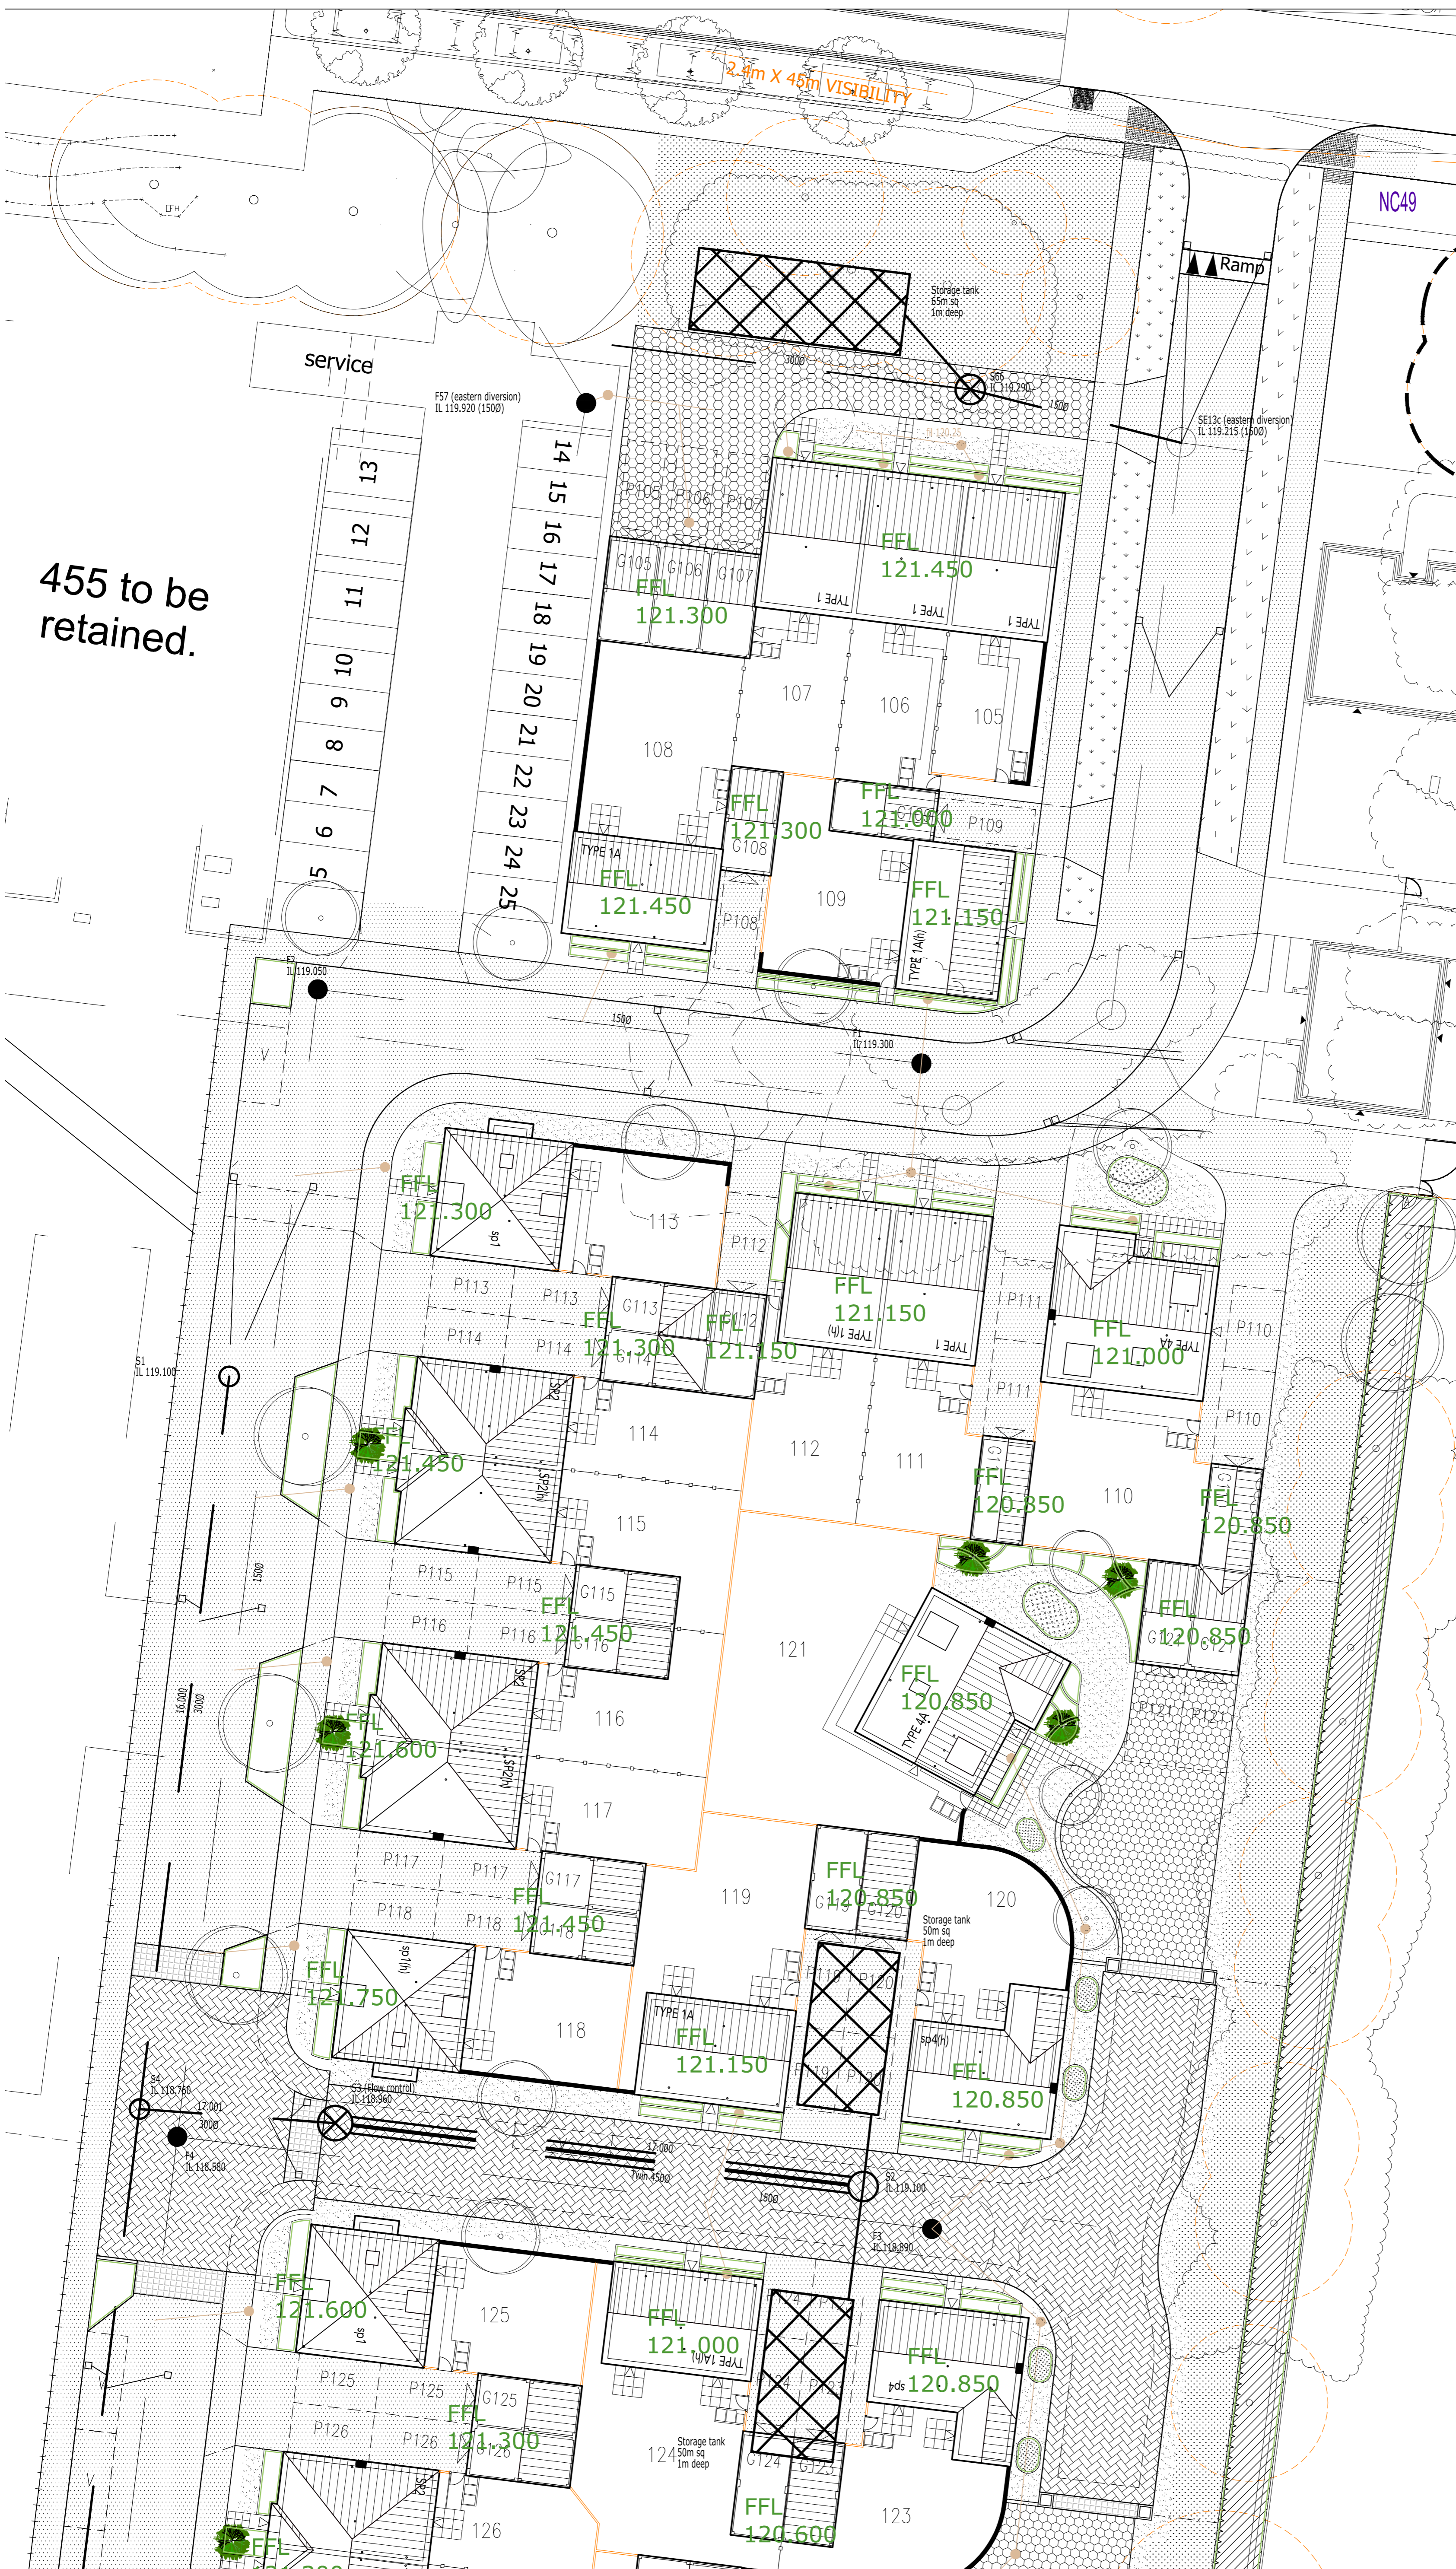
- A. 2014-10-20. Plots 9-14, 21-26 & 37-39 re-positioned and road layout in-front of those plots redesigned, sub-station relocated, gravel surface added on the private drive in front of plots 1-3 (now 105-107), shingle/stone rolled tarmac added on the private drives village green design updated, plots 6, 17, 18 swapped with type 4A and side access to plot 29 amended, Plot 20 & 36 handed and plots 1-50 renumbered as 105-154 to suit with other parcels following Local Authority's comments. SRS

- B. 2014-10-29. The frontal projections on plots 114-117, 126-129, 142 & 149 made 300mm wider, garages for plots 115-118, 125-130, 141 & 42 made eaves fronted, roof form on plots 112-114 changed, plot 139 re-aligned and plot 109 handed following Local Authority's comments. SRS

- C. 2014-11-11. The footprints for SP1 on plots 113, 118, 125, 130, 131 & 141 made 350mm wider & deeper, plots 119 & 124 repositioned and the extra visitor's space in front of plot 113 taken off, following client's request. SRS

- D. 2014-12-05. Plots 122, 133-135, and 154 repositioned to avoid existing trees at Tree Officer's request. Display of visibility splay with Camp Road clarified. DJE

- E. 2015-01-09. Title amended to Phase 3 from Phase 2 at client's request. AJA
- F. 2015-01-23. Bay window removed from house type 4A. Block Paving specification added. Loose stone grid system added in lieu of stone rolled tarmac. All at client's request. DJE

- G. 2015-02-18. Display of Close Board Fence amended at client request to improve clarity. DJE
- H. 2015-02-24. 1500mm high post & rail access gate added to the managed vegetation area at the eastern boundary, 1500mm high extra post & rail fences added along the plots to the eastern managed vegetation area and boundary extend for plot 134 extended while removing the screen wall and adding 1500mm high post & rail fence along the eastern managed vegetation area, following client's request. SRS

- I. 2015-04-07. Paved areas in front of plots 118, 125 and 141 amended, appearance of tarmac hatching adjusted, 1800mm high pier amended and low wall removed in front of plots 148 and 149 all at client request. MED

- J. 2015-06-05. Legend updated to indicate patios as 450x450 Marshalls buff slabs. AJA
